Board of County Commissioners
Clackamas County

Approval of Change Order #008 with Clackamas Progress Partners, LLC for the replacement County Courthouse. Change Order net value is \$72,858.45, leaving credits of \$663,780.35. Funding is through credits from previous Change Orders, which includes budgeted County General Funds.

CHANGE ORDER NO. [008]

PROJECT: Clackamas County Circuit Courthouse Project.

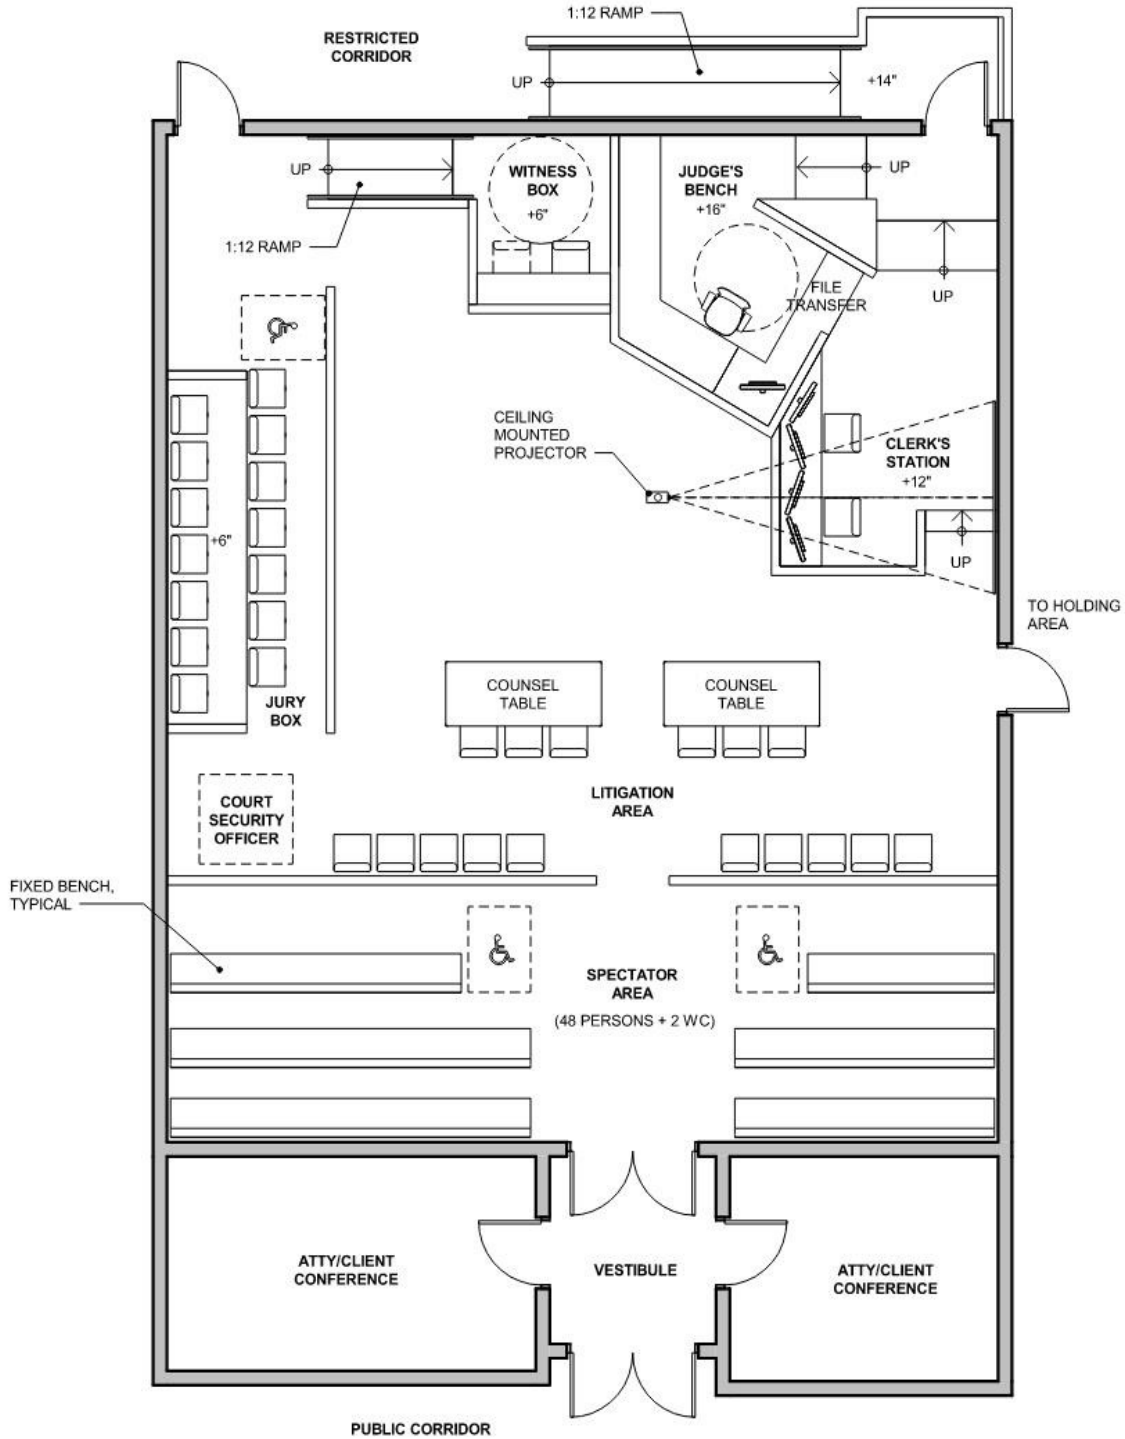
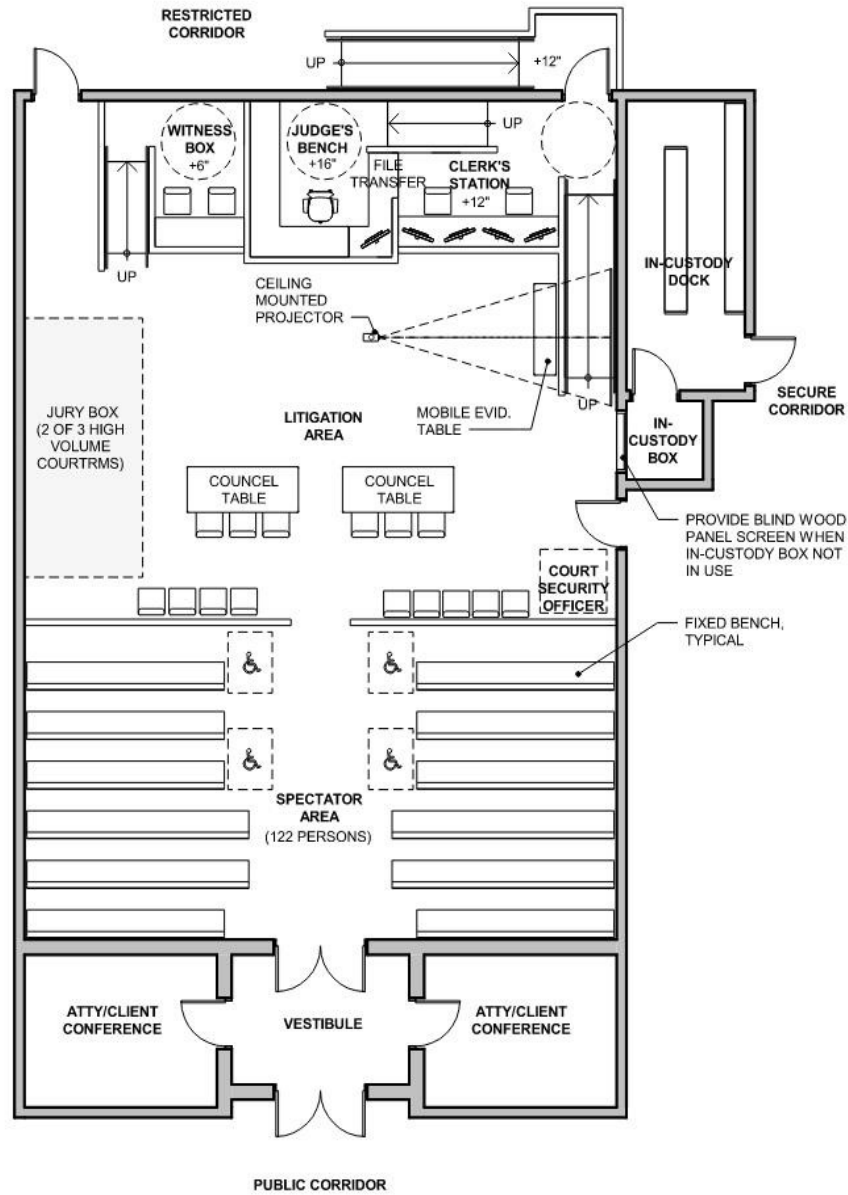
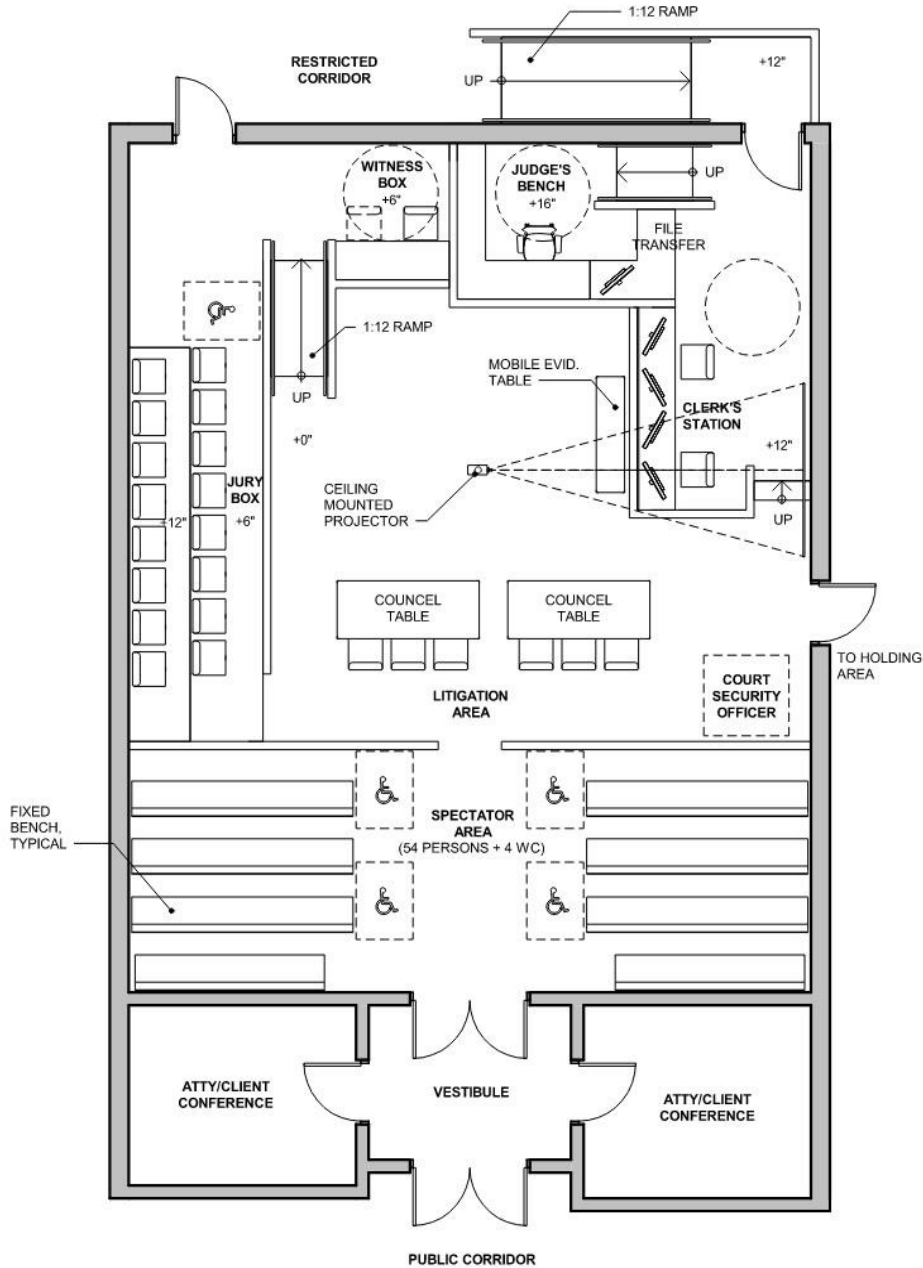
1. Remove Sheriff station from Large, High Volume and Standard Courtroom types. HR1, HR2 and HR3 to become HR1 Rev 1, HR2 Rev 1 and HR3 Rev 1, refer to Attachment A and B.

The Grand Jury Hearing Room is used for hearings of grand jury proceedings. The room must support 8 Grand Jurors.

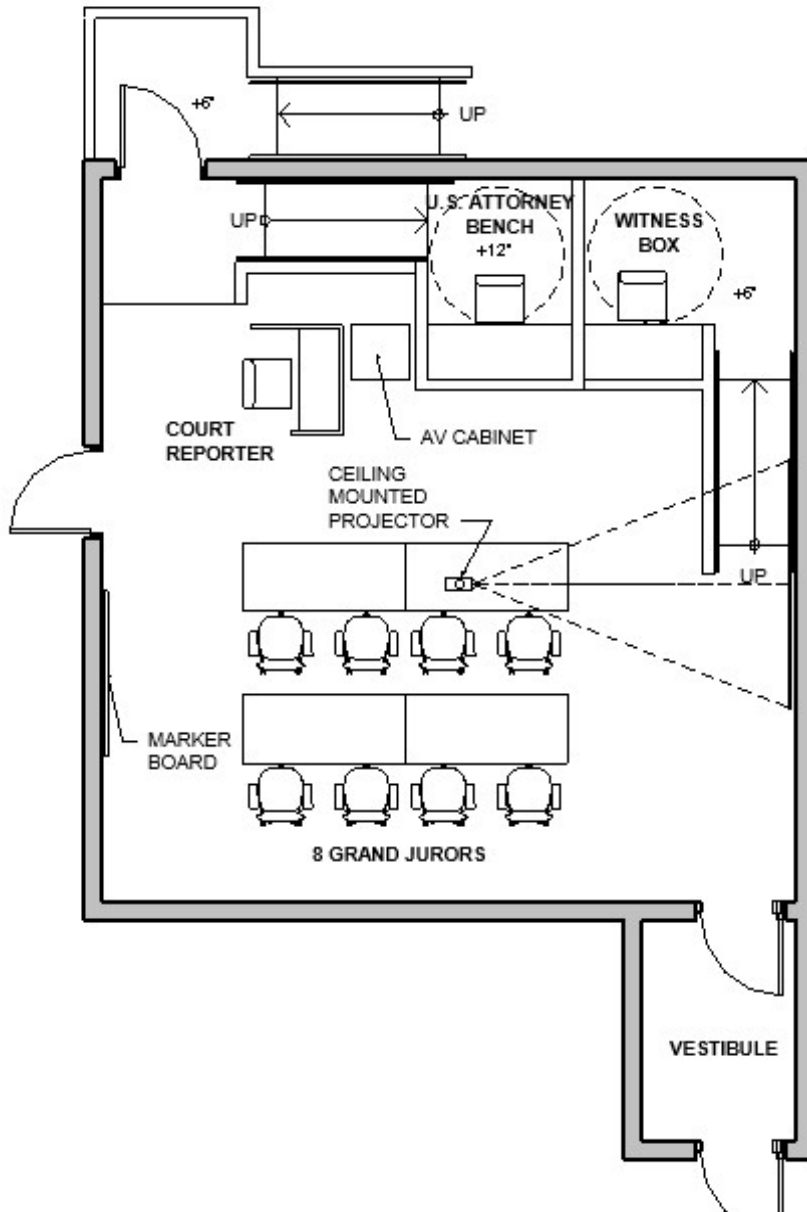
12. Add infrastructure for an ATM within Main Lobby LO1. LO1 to become LO1 Rev 1, refer to Attachment B.
13. Removal of building systems for future buildout of Grand Jury Rooms and reduced to Conference room building systems. Reference Attachment A.

This room is used by prospective jurors as a quiet space to relax or work remotely. The Juror Lounge is an alcove off the Jury Assembly room. Half of the total allotted area is to be located on each side of the Jury Assembly Room.

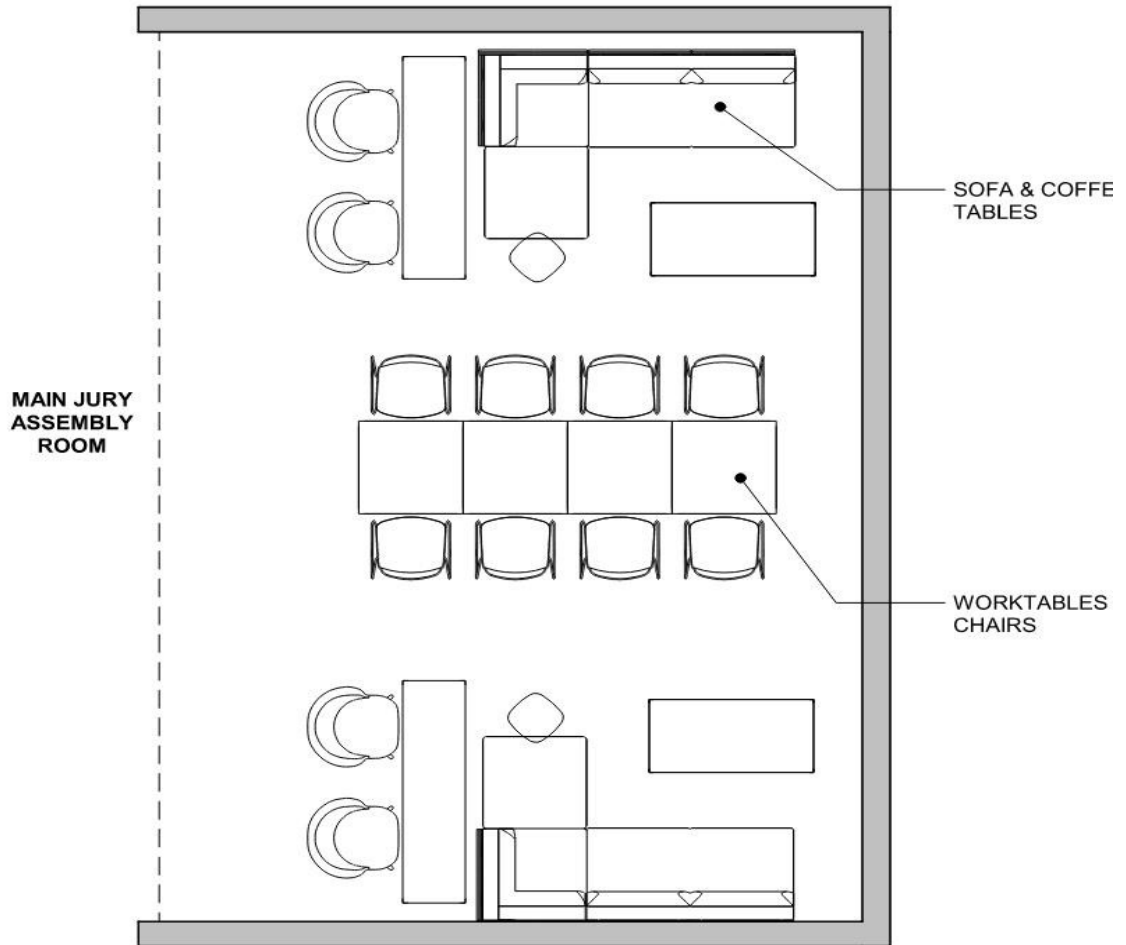
11. Addition of closed walled chair storage space within Jury Lounge JA2 Rev 1. Provide adequate space for the storage of additional chairs. JA2 Rev 1 to become JA2 Rev 2, refer to Attachment B.

Juror break room is used by prospective jurors for obtaining food, drinks and casual dining.

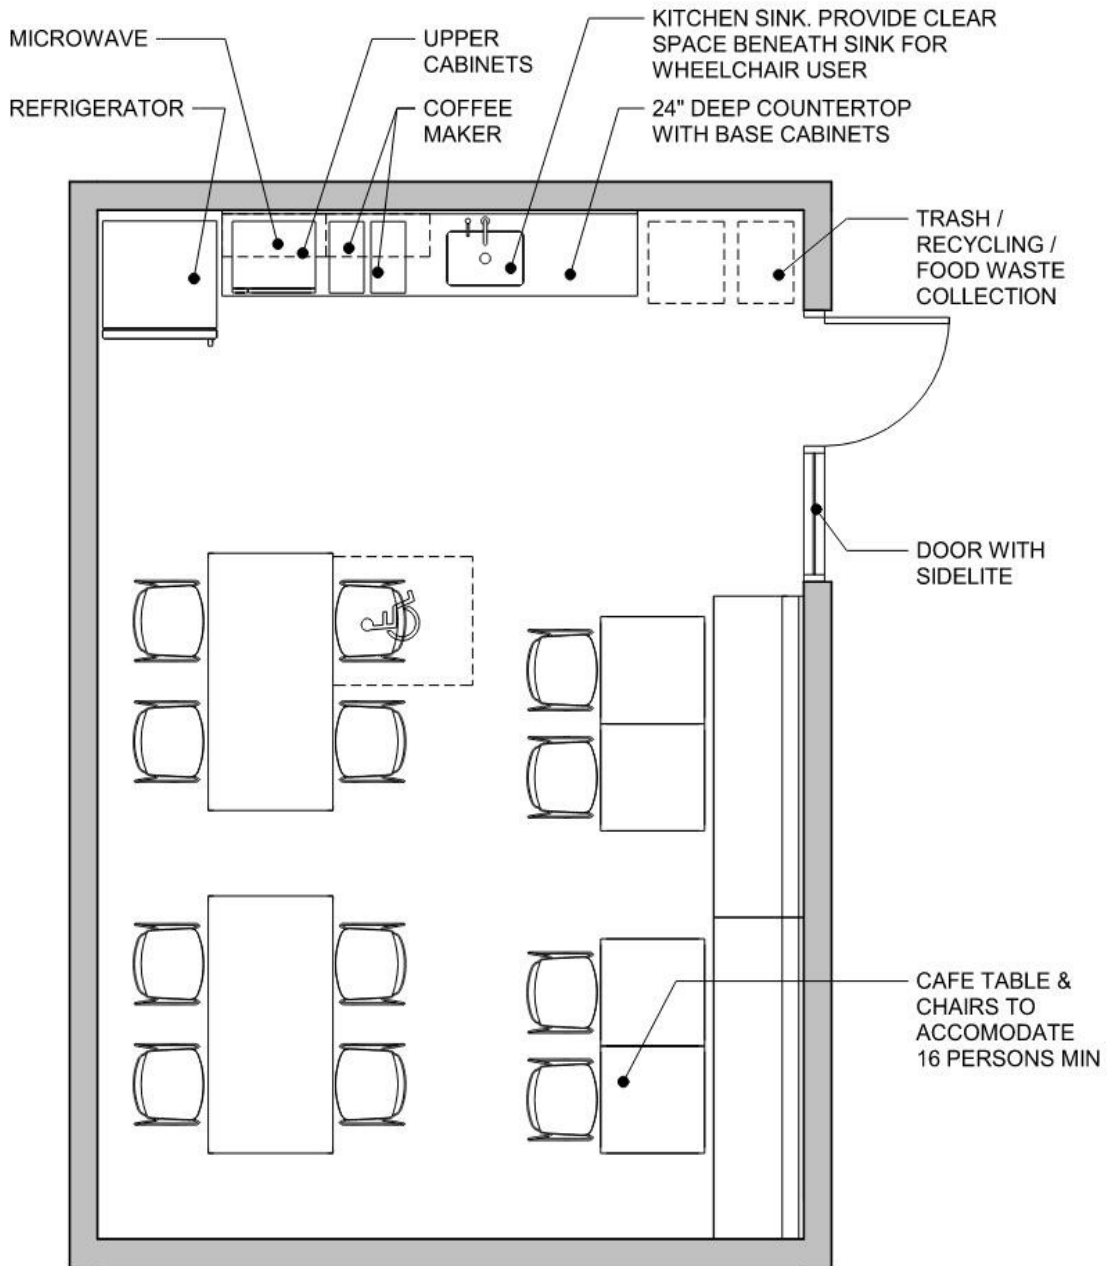
8. Add hot tap into the main water line with metering for the Courthouse irrigation system.
9. Add Notice board to Galley/Beverage SS6, SS7 and Juror Break Area and Galley JA3. SS6, SS7 and JA3 to become SS6 Rev 1, SS7 Rev 1 and JA3 Rev 1. Refer to Attachment B.

10. Create an open plan kitchenette layout at the Juror break and Seating Area JA3 and locate toward the interior of the Jury Assembly area to maximize exterior wall for Jury Lounge JA2. This item added to JA3 Rev 1, refer to Attachment B.

Work/Copy Room is used by staff for daily office tasks such as copying, sorting, obtaining supplies, etc.

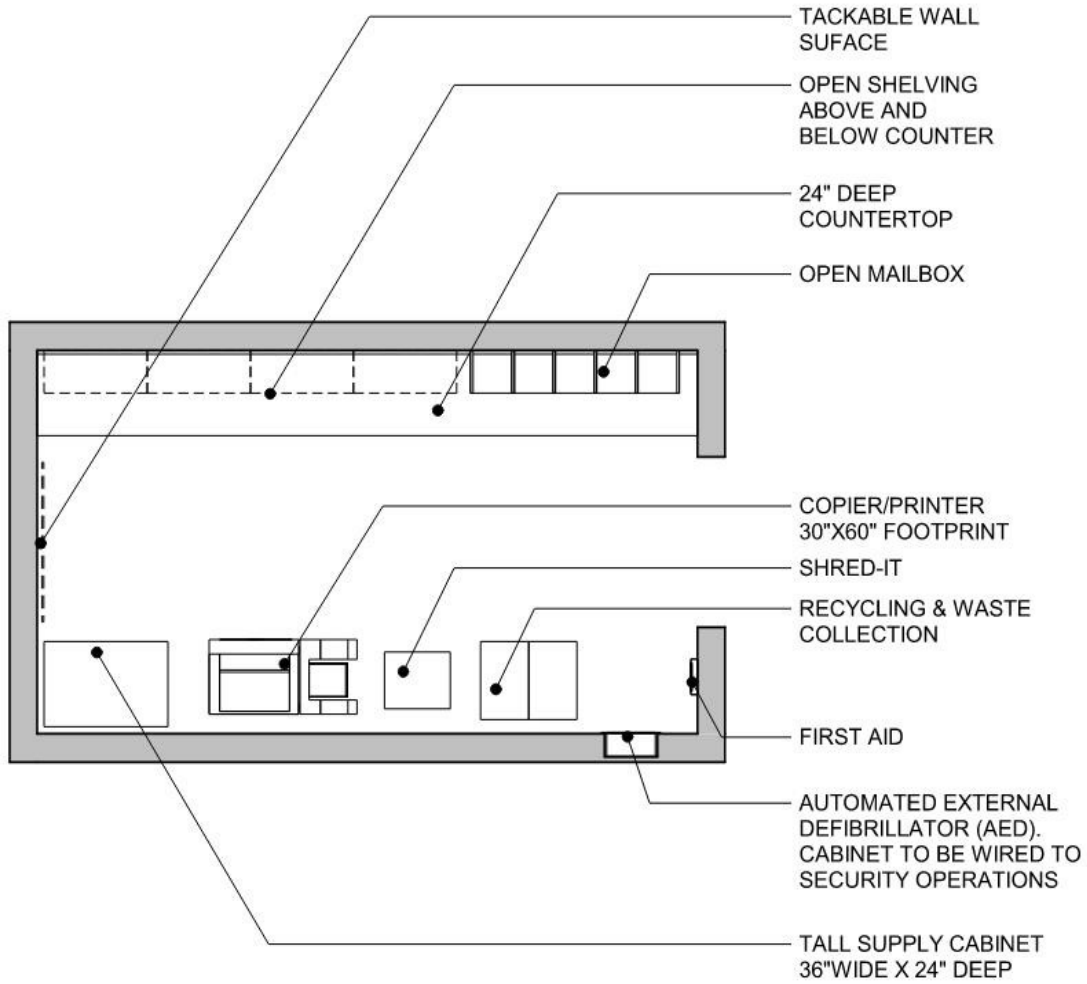
4. Increase depth of countertop in OS1 Copy/Work Room from 24” to 30”. OS1 to become OS1 Rev 1, refer to Attachment B.
5. Add wheelchair charging station to the Public Lounge PS1 Rev 1 on floors 3 through 6. PS1 Rev 1 to become PS1 Rev 2, refer to Attachment B.
